Proposal for a causal transmission line model

IEEE P802.3bj Task Force
March 2014

Problem statement

Pulse response comparison

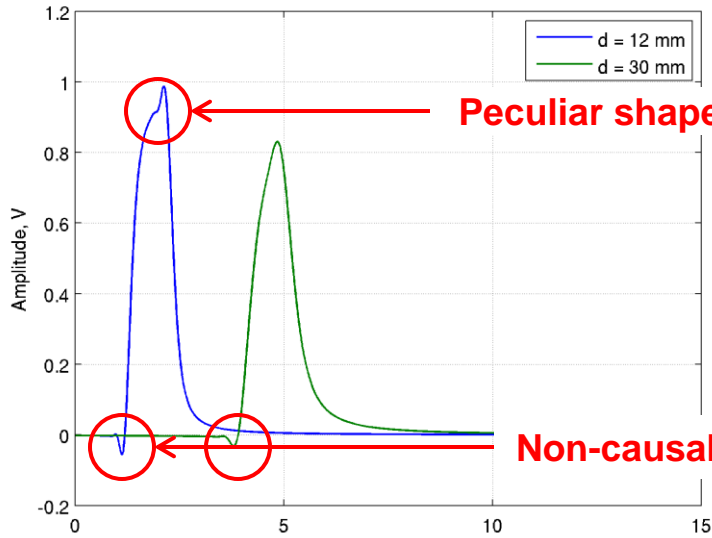
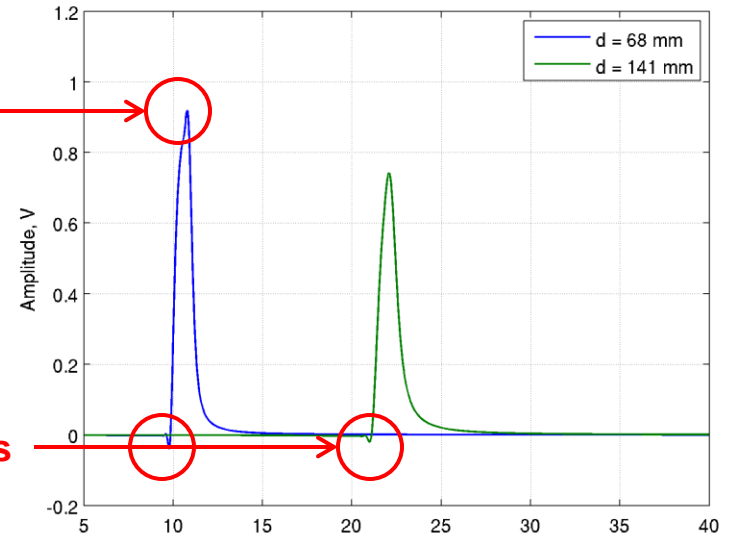
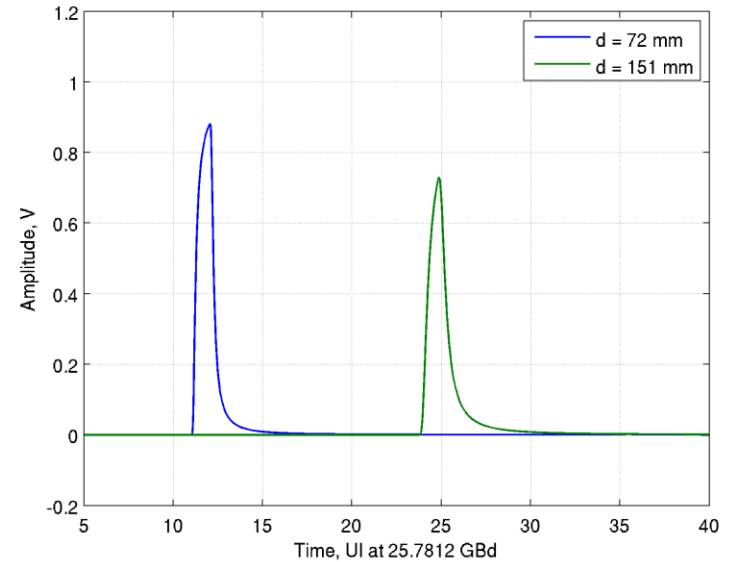
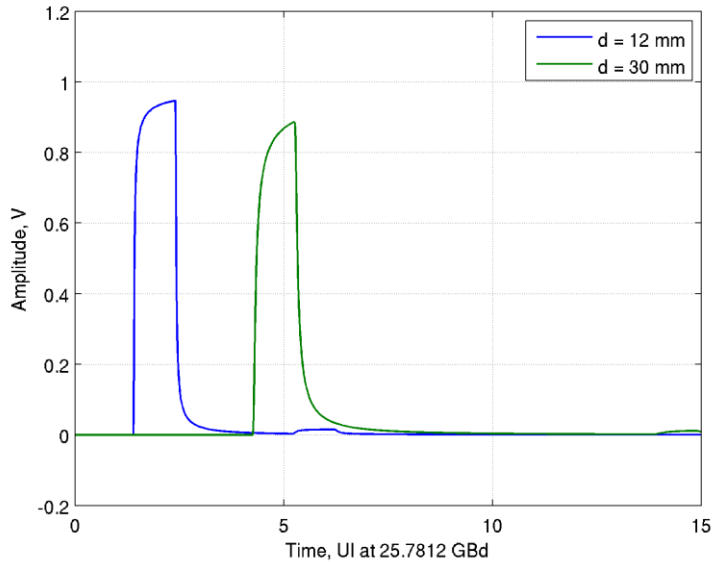
- Insertion loss deviation in the 1 mm section was incorrectly modeled with a term proportional to f^2
- With the insertion loss deviation correctly modeled, the f^2 term is no longer needed but this reduces the insertion loss at high frequencies
- To compensate, changes are required to 92.10.7.1.1
- Change the length of the aggressor transmitter transmission line to 72 mm (from 68 mm)
- Change the length of the victim transmitter and receiver transmission line to 151 mm (from 141 mm)

- Replace the package and host transmission line models in Draft 3.1 with the models proposed in this presentation
- Simpler models that provide more accurate representations of the transmission lines
- Causal by construction
- Adjustment to host transmission line length needed to maintain the 3 and 6.26 dB insertion loss targets
- The impact on the COM is shown in [Appendix C](#).
- A companion document illustrating detailed changes to the draft will be provided
